Product Change Notification / LIAL-09UEWG307

CCB 4395 Final Notice: Qualification of MMT as an additional assembly site for selected Micrel products available in 16L VQFN (3x3x1.00mm) package.

PCN #: LIAL-09UEWG307

CCB 4395
Pre and Post Change Summary
PCN #: LIAL-09UEWG307

UNIS

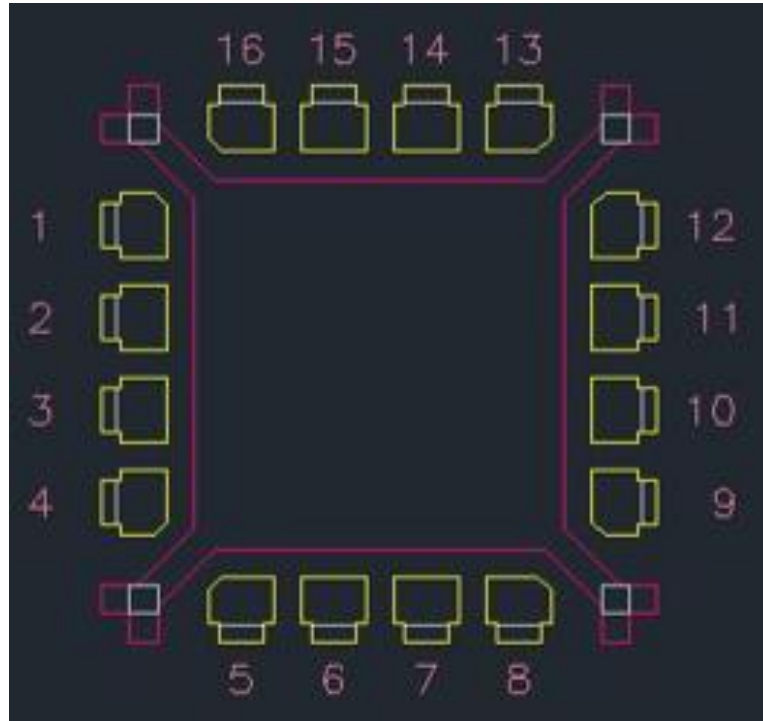
Lead frame Comparison

| Lead Frame Lead Lock | No |
| Lead frame paddle size | 69 x 69 mils |

MMT

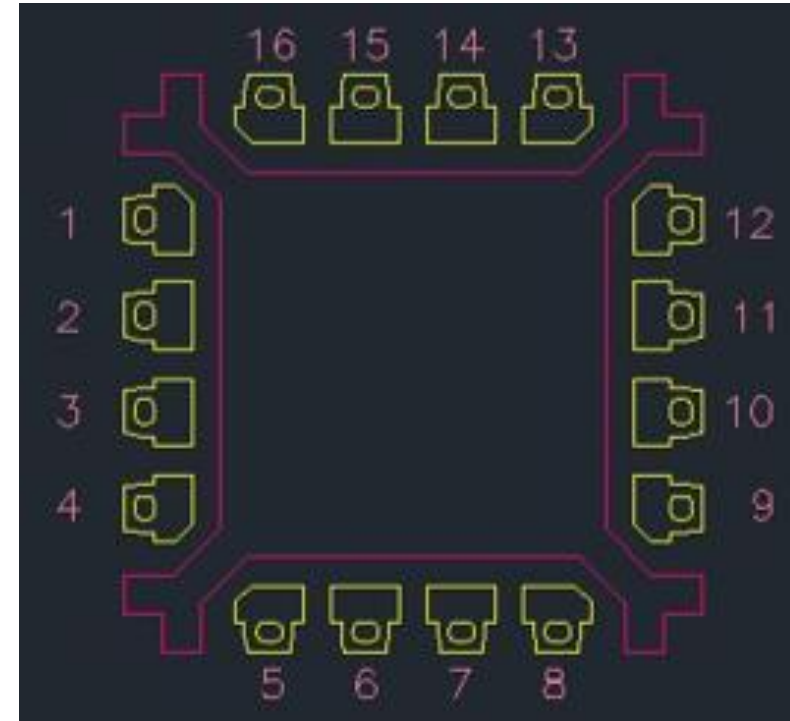
| Lead Frame Lead Lock | Yes |
| Lead frame paddle size | 75 x 75 mils |
